**ISSUE:** Certificate of Appropriateness for alterations

**APPLICANT:** City of Alexandria represented by Lisa Lettieri, Architect

**LOCATION:** Old & Historic Alexandria District  
301 King Street

**Minutes from October 16, 2025 BAR hearing**

PROPOSED HYPHEN DETAILS

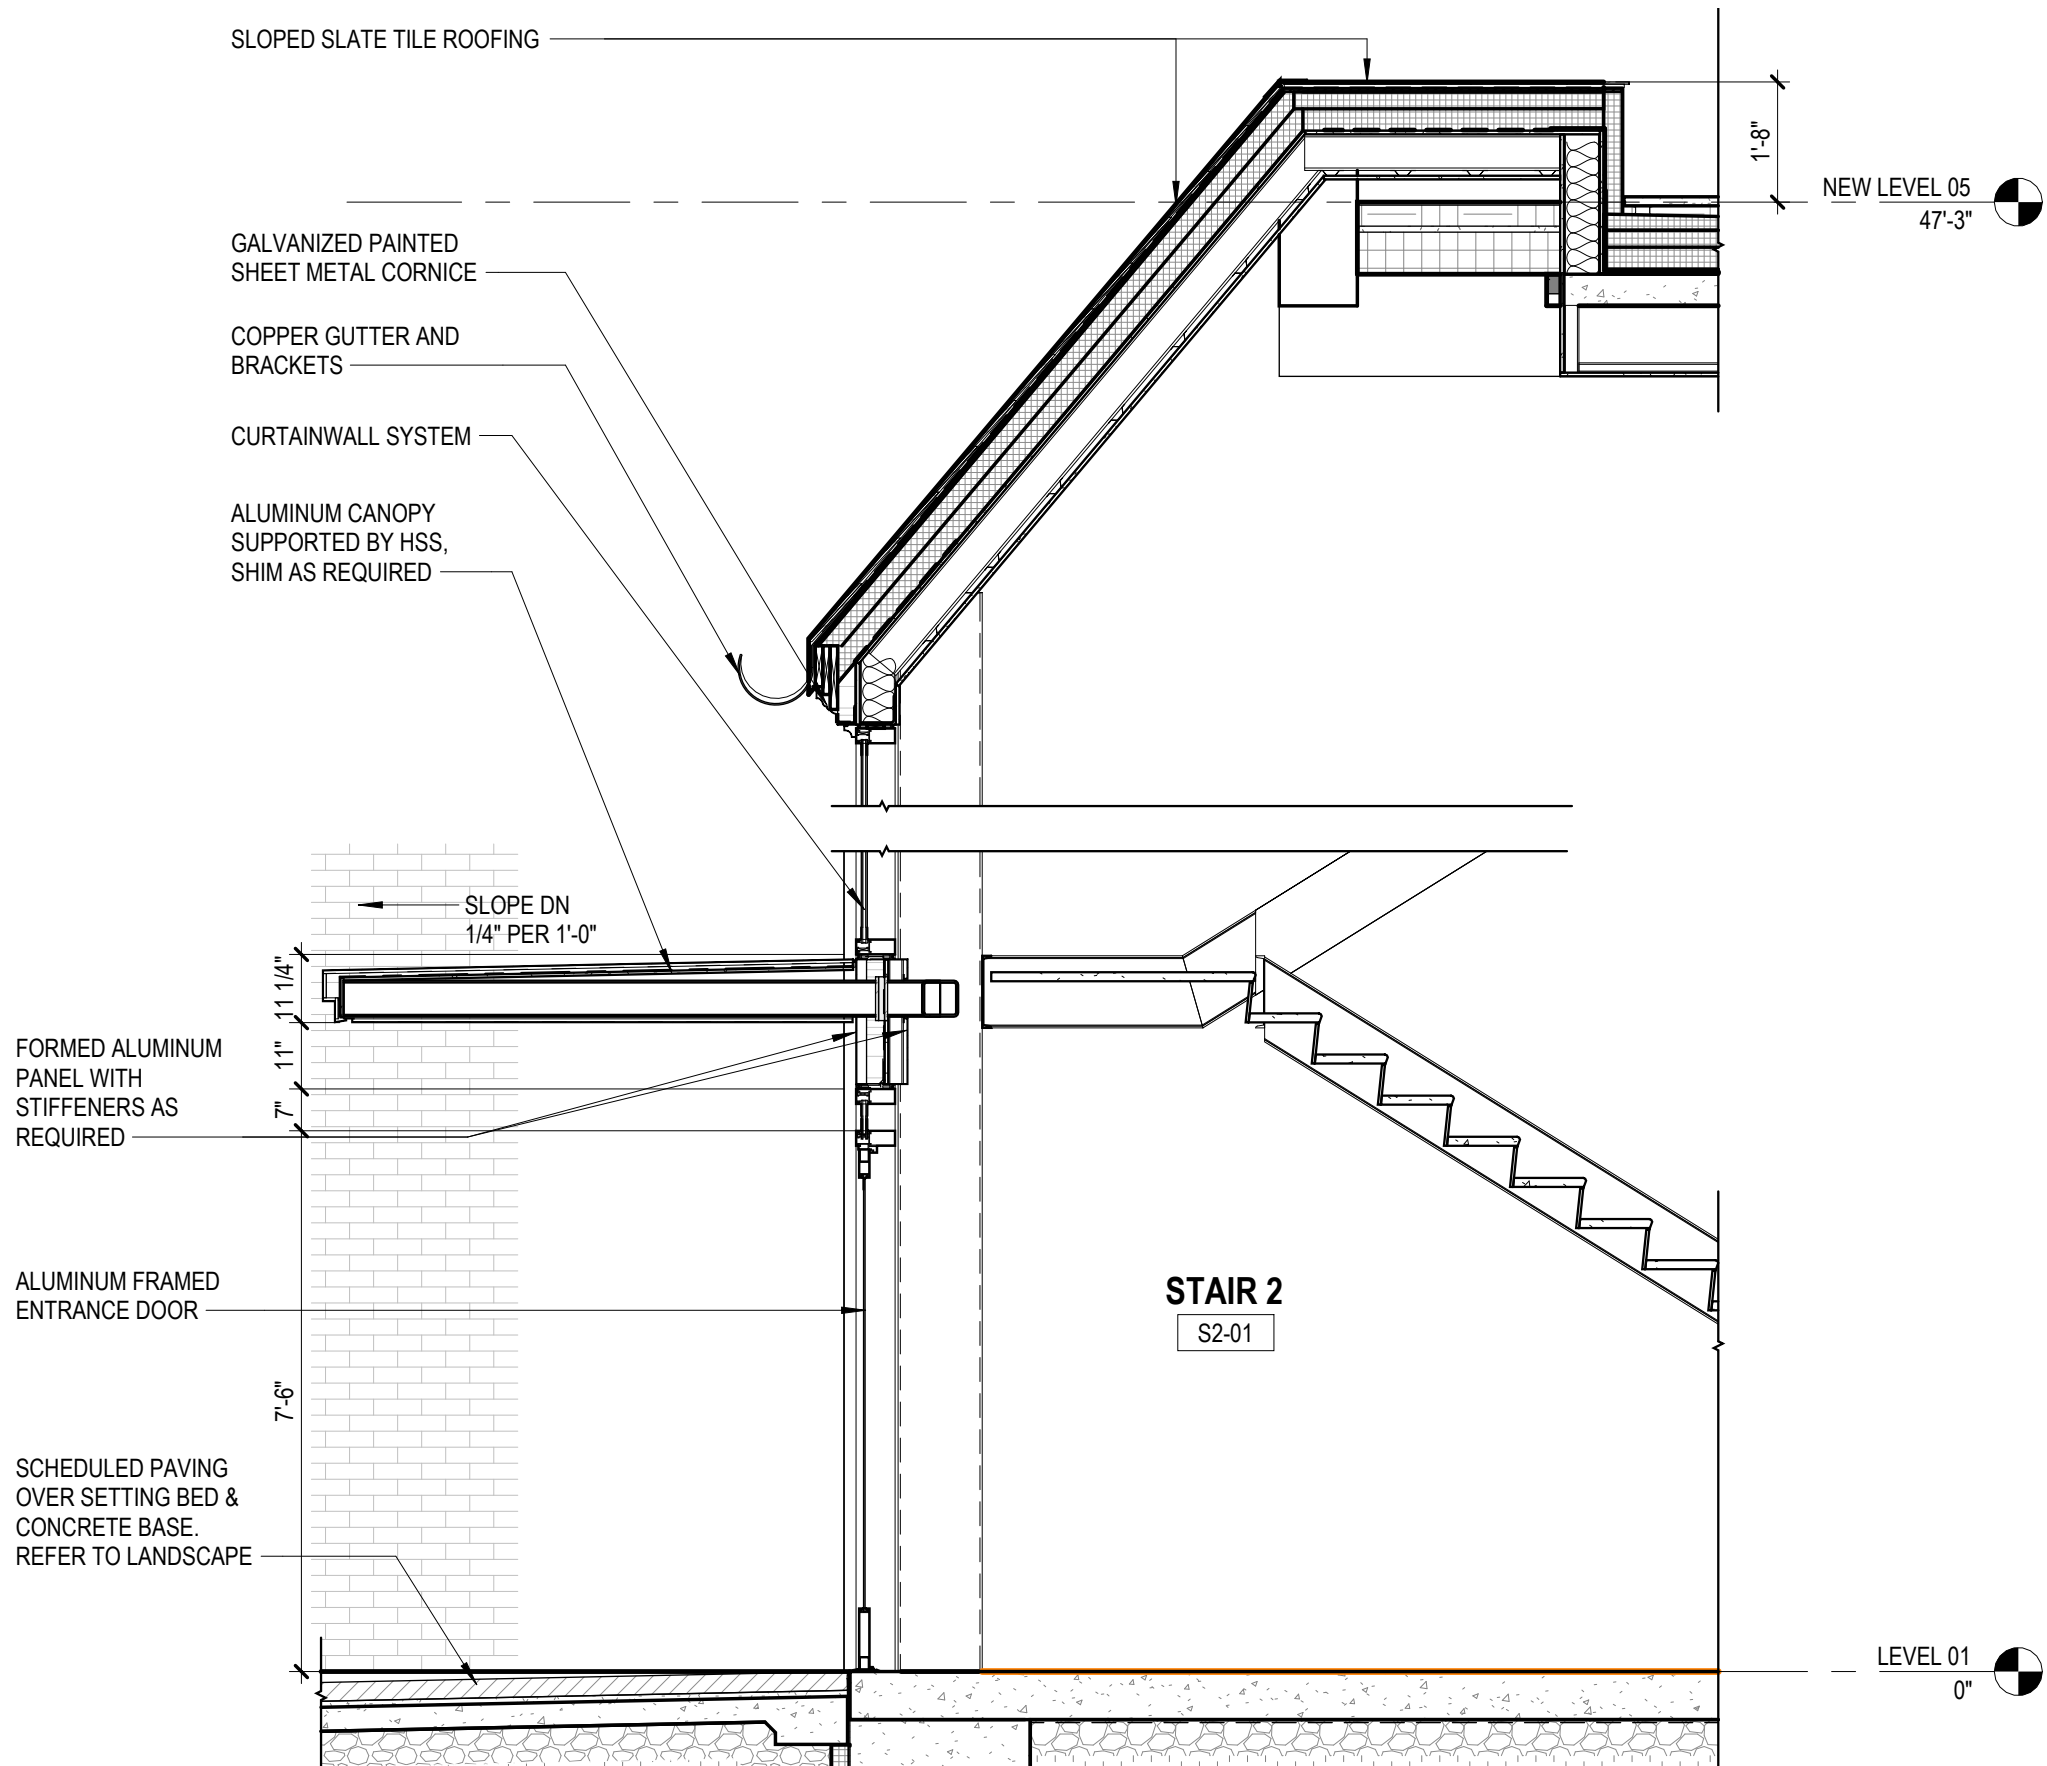
John Patrick, HARC, appreciated the scope of restoration on the building. He prefers the new design for the building entrance but opposes the use of full height glazing at the hyphens, preferring a solid wall in this location. He also expressed concern regarding the extent of glazing at the fifth floor.

Melissa Kuennen, NOTICE, recommended that the design team continue to revise the design similar to proposals made by members of the public, stating that the proposed design for the central portion of the south elevation is not consistent with the overall building design. She noted that the entrance is awkward and that the glazed hyphens are incompatible with the overall building design.

In a number of previously approved additions, the Board has supported the use of a vertical slot of some sort to provide the prescribed differentiation between the historic and a later addition. The proposed modifications to the east and west ends of the 1961 addition create this vertical slot by “offsetting the footprint” of the building setting the face of the hyphen a significant distance behind the face of the addition. The use of full height glazing on this component addresses the *Design Guidelines* direction not to “obscure or dilute the architectural and historic importance of an existing building” by allowing for the original exterior wall of the 1871 portion of the building to be visible from the exterior. Staff supports this approach as consistent with the Design Guidelines and with previously approved additions.
